United States Patent and Trademark Office

APPLICATION NO.	FILING DATE	FIRST NAMED INVENTOR	ATTORNEY DOCKET NO.	CONFIRMATION NO.
10/664,195	09/17/2003	Todd M. Bjork	M81.12-0068	3894
27367	7590 08/25/2006		EXAMINER	
WESTMAN CHAMPLIN & KELLY, P.A. SUITE 1400 900 SECOND AVENUE SOUTH MINNEAPOLIS, MN 55402-3319			RAMANA, ANURADHA	
			ART UNIT	PAPER NUMBER
			3733	
			DATE MAILED: 08/25/2006

DETAILED ACTION

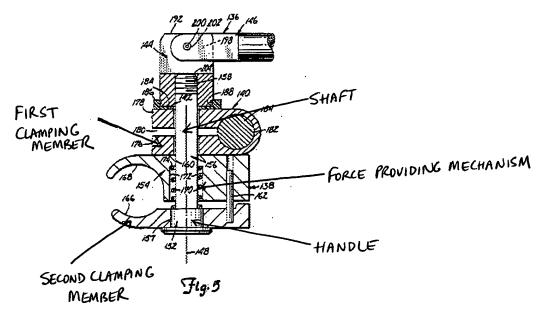
Claims 1, 2 and 8 are rejected under 35 U.S.C. 102(b) as being anticipated by LeVahn et al. (US 4,949,707).

LeVahn et al. disclose a surgical joint including a first clamping member, a second clamping member a shaft 156 positioned within the attachment end of the first clamping member and in communication with the second clamping member and a spring or "force providing mechanism" 170 disposed about the shaft wherein a handle is attached to the force providing mechanism (Fig. 5, col. 6, lines 48-68 and col. 7, lines 1-19). See marked up Fig. 5 below.

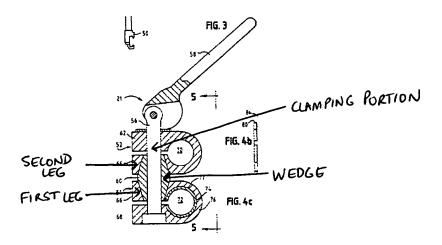
Claims 15-16 and 19 are rejected under 35 U.S.C. 102(b) as being anticipated by Farley et al. (US 6,033,363).

Farley et al. disclose a surgical clamp including a clamping portion 56, a first leg 54 and a second leg 64 and a wedge 60 disposed between the first and second legs wherein the wedge is movable to force the legs in opposite directions (Fig. 3 and col. 3, lines 29-40). See marked up Fig. 3 below.
